## COUNTY OF LINCOLN, NORTH CAROLINA

Date: October 19, 2010

Re: UDO Proposed Amendments #2010-2  
Brian Temerson, applicant

## **UDO Proposed Amendment #2010-2**

Figure 1. Service Bay Orientation

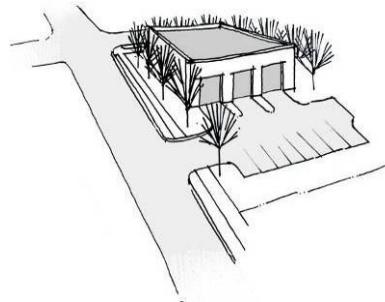
Service bay doors shall not be oriented toward the road or any residential use, unless such bays are screened from view from the road and residential uses.

A service bay door of an accessory automatic car wash may be oriented toward the road provided the automatic car wash meets the provisions of

§4.4.8.
